Service Bulletin

Bulletin No.: 17-NA-371

Subject: Sunshade Auto Open Feature Noisy or Inoperative, and/or Sunshade Latch Handle Broken

4900563

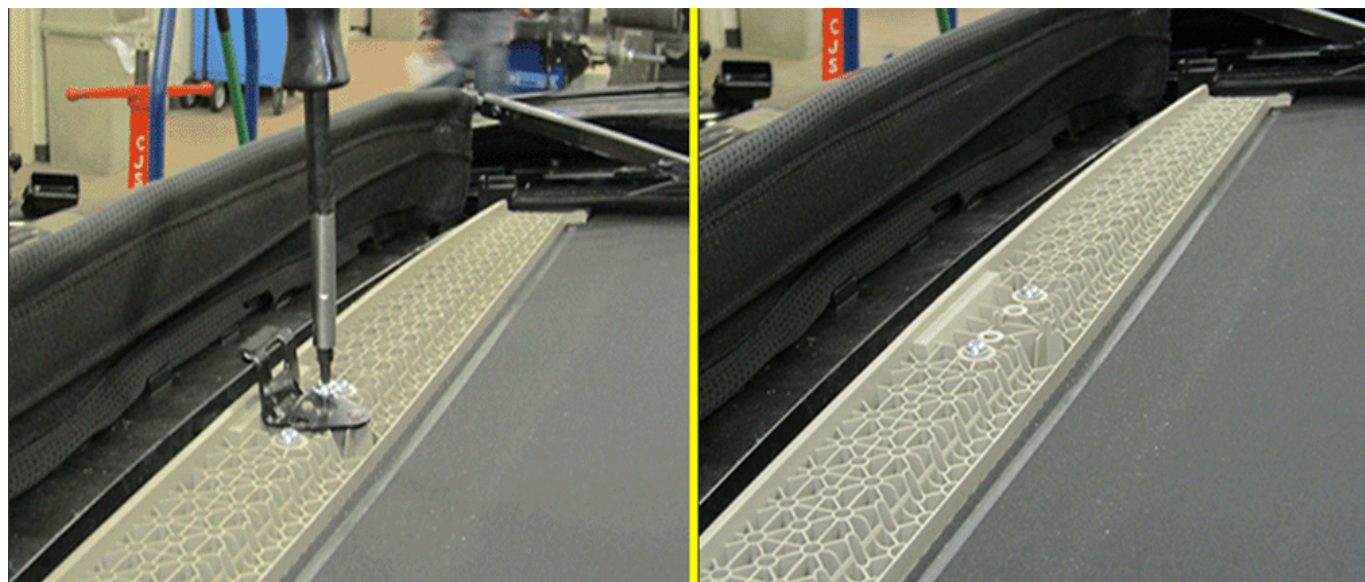
1. Open the front sunshade, then open the front sunroof window. Pull down slightly on the front edge of the sunshade and close it with the sunroof open.

4900568

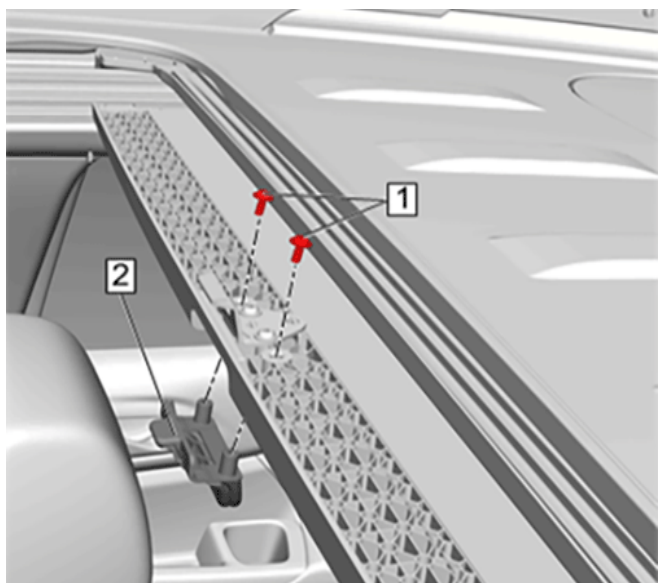
2. Remove the two screws and the sunshade auto open bracket from the sunshade.

Note: Please explain to the customer that the sunshade auto open feature has been eliminated as a product improvement.
